POLICY REPORT  
DEVELOPMENT AND BUILDING

Report Date: January 16, 2018  
Contact: Susan Haid  
Contact No.: 604.871.6431  
RTS No.: 12336  
VanRIMS No.: 08-2000-20  
Meeting Date: January 30, 2018

TO: Vancouver City Council  
FROM: General Manager of Planning, Urban Design and Sustainability  
SUBJECT: CD-1 Rezoning: 431-455 West King Edward Avenue

Figure 2 - Site Plan

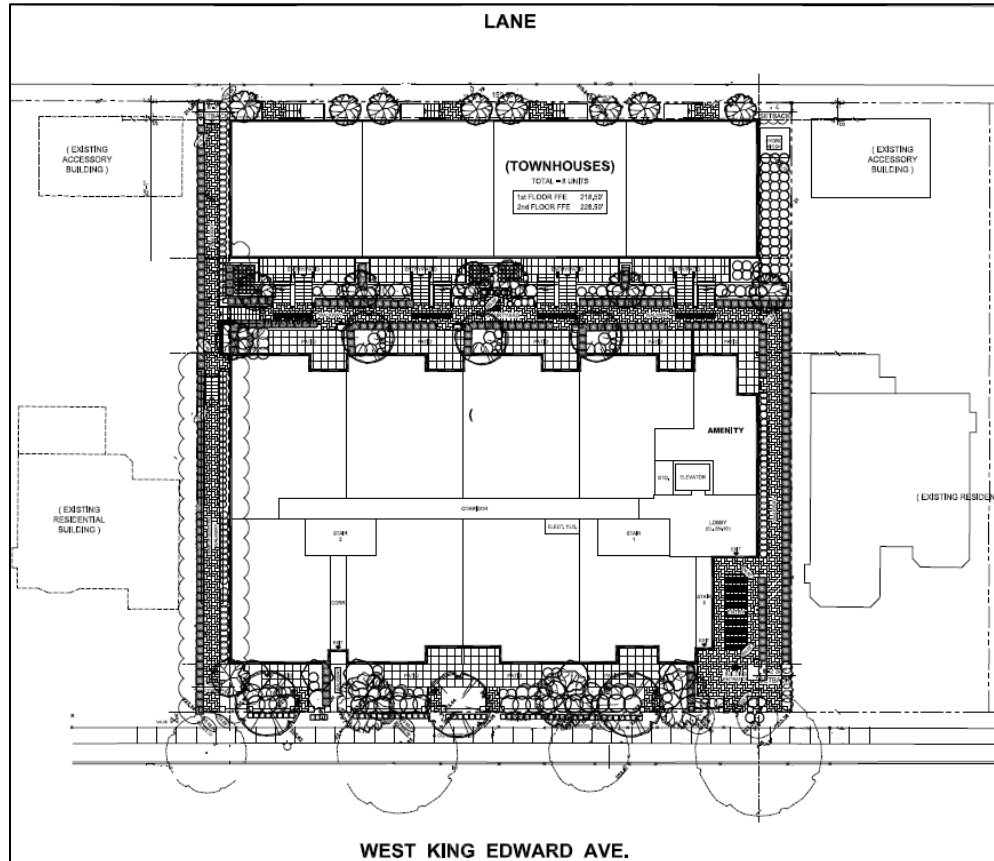
- 1. Design development to provide a substantial break (no less than 10 ft.) in the laneway townhouse building which will result in two separate buildings.

- 2. Design development to improve the courtyard performance by increasing its dimension and by lowering it to be closer to natural grade and better related to units that are located along it.

- 3. Design development to re-locate the indoor amenity space to the rooftop and along with it, provide a co-located outdoor amenity space. An increase is sought on each of these spaces by providing no less than 700 sq. ft. for the indoor amenity and 1,400 sq. ft. for the outdoor amenity space.

8. Design development to improve the livability of the common courtyard by the following:
  - (i) Widen the distance between buildings to achieve a more usable space, with the common walkway to be a minimum 8 ft. wide.
  - (ii) Provide more usable common space in the area between the two townhouse buildings by replacing some of the planted area with additional seating or other common uses.
  - (iii) Provide more opportunities for informal seating and gathering by including some lawn areas, seat walls and additional benches.
  - (iv) Delete water feature and replace with a planting bed, flush with the courtyard rather than raised, for a smooth, unobstructed visual experience. This will require alterations to the parkade height in order to allow adequate depth of soil.

Note to Applicant: A single building in excess of 80 ft. is not supported in the *Cambie Corridor Plan*. This refinement will improve the scale and livability of the townhouse buildings at the lane.

Note to Applicant: This may be achieved by optimizing the parking structure and/or lowering the elevation of the main building. Units in the main building can be considered along the courtyard to provide amenity to the units, and to enliven the courtyard space.

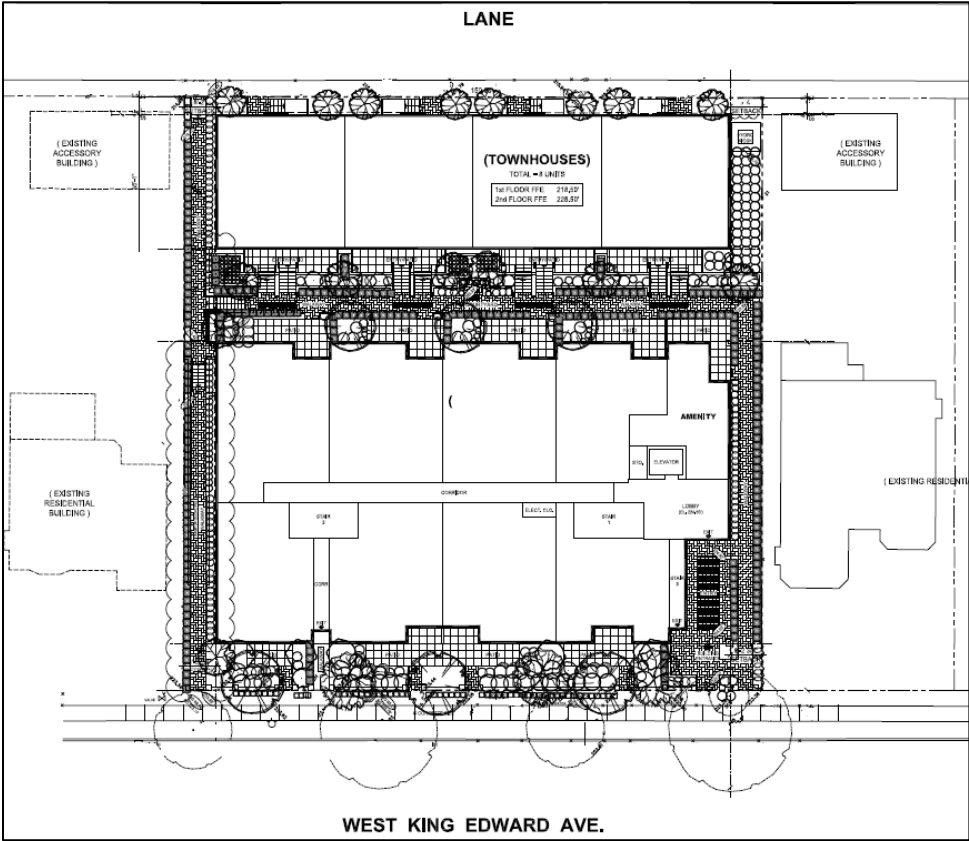
The interface should have a different stepping strategy (to properly fit on the site), it is too tight and there are concerns that glazing could create interface problems with adjacent building. One panel member recommended changing the 8 ft. setback and shifting it towards King Edward Avenue because it would move it south and help with the daylight impacts to the courtyard. Panel members noted three bathrooms and additional media rooms in some of the units were an inefficient use of space and did not warrant the extra density proposed. Another panel member mentioned the depth of the floorplate was excessive for the main building, and a few panel members mentioned the architectural overhang and balconies are unnecessary on the north side.

The courtyard in the current scheme is not a courtyard but merely a circulation space according to one panel member. Another panel member recommended the applicant reconsider the spaces as actual townhouses and create better access to the courtyard.

Overall, the current design needs to be revised to make more space for open space and landscaping.

**Applicant's Response:** The applicant thanked the panel and will take the comments into consideration.
